Application No.: 10/049,865 6 Docket No.: 449122021000

REMARKS

AMENDMENTS TO THE DRAWINGS

REPLACEMENT SHEET

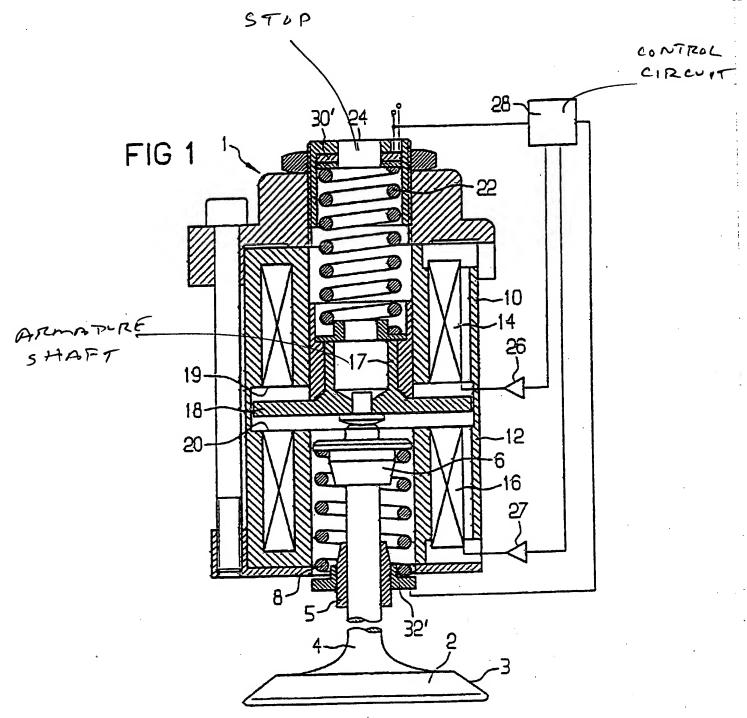
The drawings have been objected to due to informalities. The drawings (figures 1 and 3) have been amended as indicated in the attached.

The attached sheet(s) of drawings includes changes to Figures 1 and 3.
